文件编号 Document No.	ESP-07-2-007-03	文件名称 Document Name	产品/工艺变更通知 Product/Process Change Notice (PCN)
文件版本 Document Version	1.4	保存期限 Retention Period	5 年 5 years

基于 ESP32-S2FH2 芯片的 ESP32-S2 系列产品的芯片版本升级 Upgrade Chip Revision of ESP32-S2 Series Products Based on ESP32-S2FH2			
PCN 编号 PCN No.	PCN20231201	提出日期 Issue Date of PCN	2023/12/05
变更日期 Proposed Date of Change	2023/12/31	预计变更后产品首次出货日期 Proposed Date of First Shipment After Change	2023/12/31
PCN 类型 / PCN Category	<input type="checkbox"/> 客户需要批准/ Customer Approval Required <input checked="" type="checkbox"/> 客户通知/ Customer Notification

6. 变更前后产品处理/ How to Deal with Products

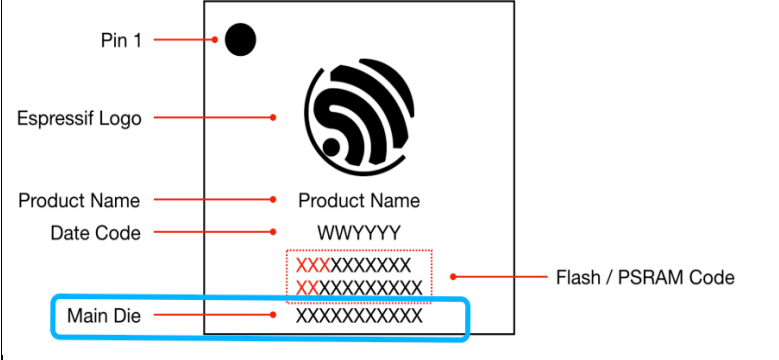
FIFO
